ADDENDUM NO. 2

- A. Date: 19 March 2013
- B. From: Bahr Vermeer and Haecker Architects, Ltd.
- C. To: Prospective Bidders.
- D. Project: Lexington Public Schools Lexington Middle School and Community Recreation Facility Addition 100% Contract Documents
- E. This addendum is issued by the Architect to all bidders of record prior to receipt of proposals. Bidders shall acknowledge receipt of this addendum by so indicating on the Bid Form. Failure to do so may subject Bidder to disqualification.
- F. All information and instructions given herein shall become a part of the Contract Documents.

ADDENDUM # 2

PROJECT Lexington Middle School & CRF Addition

SHEET
E3.2D

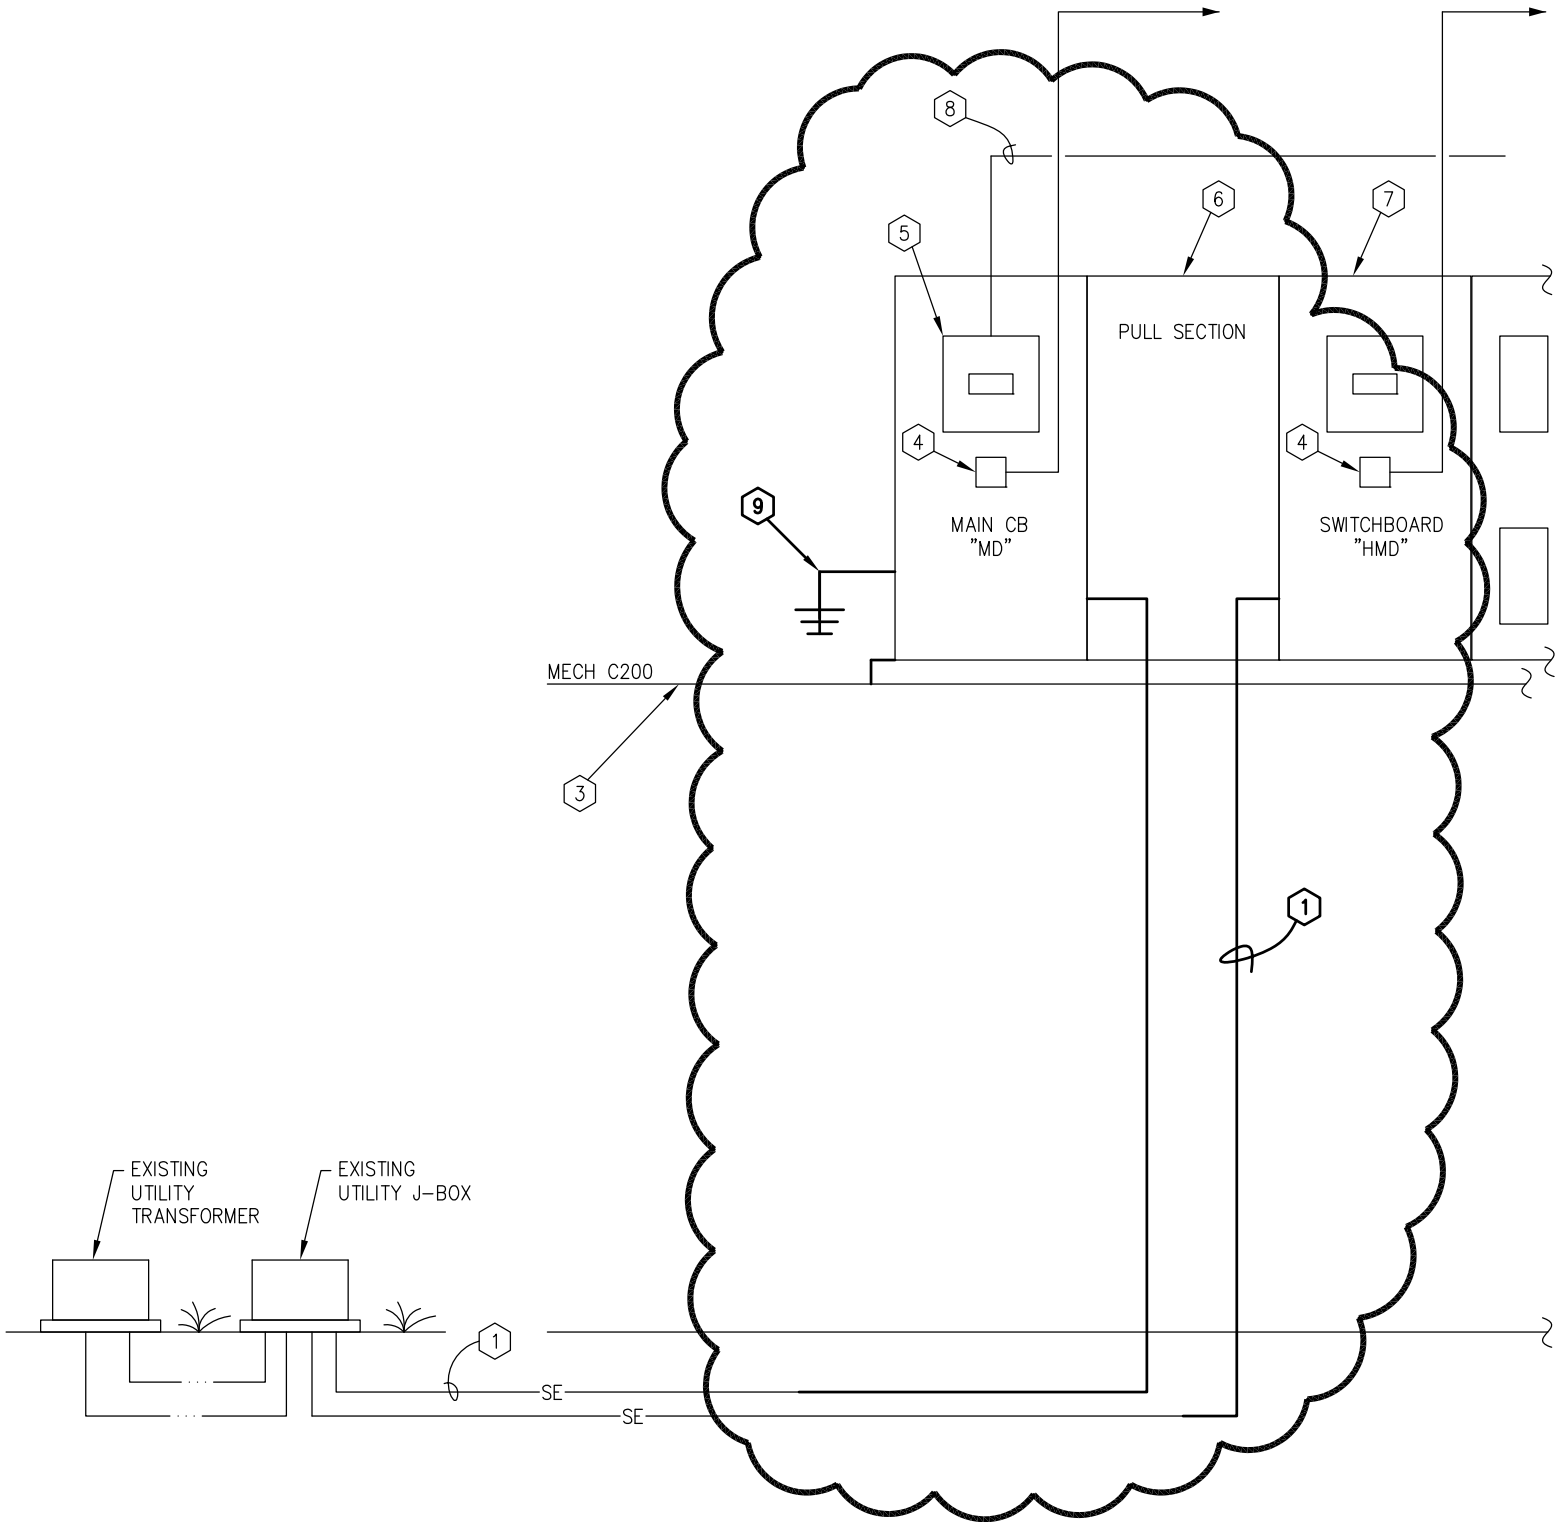
- F. The speaker cable in the Rec Center shall be extended to IT CLST D132.1. See attached drawings E3.2D #1 & #2.
 - G. Add a fire alarm pull station by Stair #2 S202 and by Stair #5 S205.
